Access Compliance Report

Public Rights-of-Way

(Curb Ramps)

Intersection ID: 44464	Main Street: BAYVIEW_PY	Cross Street: VALCOURT_RD	Location: NW
ADA ID: 5B5E906F29D9	Ramp Type: PerpDiag	Initial Pass/Fail: Fail	Overall Compliance: No
Codes/Mitigation Info/Possible Solution		Field Measurements/Component Compliance	
Severity Score: 10

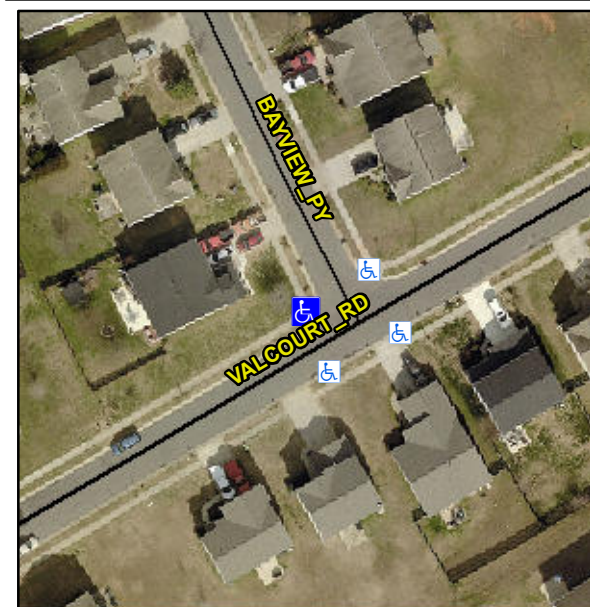
Not Found, R304.5.1, R304.5.3

Compliance	Description	Data	Compliance	Description	Data
N/A	Ramp Length (in)	49.5	Yes	Ramp Slope (%)	5.3
No	Ramp Width (in)	41.0	No	Ramp XSlope (%)	4.2
N/A	Flare Type LT	N/A	N/A	Flare Type RT	N/A
N/A	Flare Slope LT (%)	N/A	N/A	Flare Slope RT (%)	N/A
N/A	Flare Traversable LT?	N/A	N/A	Flare Traversable RT?	N/A
N/A	Landing Length (in)	N/A	N/A	DWS Provided?	N/A
N/A	Landing Width (in)	N/A	N/A	DWS Contrast?	N/A
N/A	Landing Slope (%)	N/A	N/A	DWS Length (in)	N/A
N/A	Landing X Slope (%)	N/A	N/A	DWS Full Width?	N/A
N/A	Landing Curb? (Y/N)	N/A	N/A	DWS Offset (in)	N/A
N/A	Shared Landing?	N/A			
N/A	Gutter Ponding?	N/A	N/A	Gutter Slope (%)	N/A
N/A	Gutter Lip Ht (in)	N/A	N/A	Gutter X Slope (%)	N/A
N/A	Painted X Walk1?	No	N/A	Painted X Walk2?	No
	X Walk 1 Direction	To S		X Walk 2 Direction	To E
N/A	X Walk 1 Width (in)	N/A	N/A	X Walk 2 Width (in)	N/A
	X Walk 1 Slope (%)	5.1		X Walk 2 Slope (%)	4.8
	X Walk 1 X Slope (%)	4.8		X Walk 2 X Slope (%)	2.5

Remove & Replace Curb Ramp With Two New Directional Ramps or Equivalent.
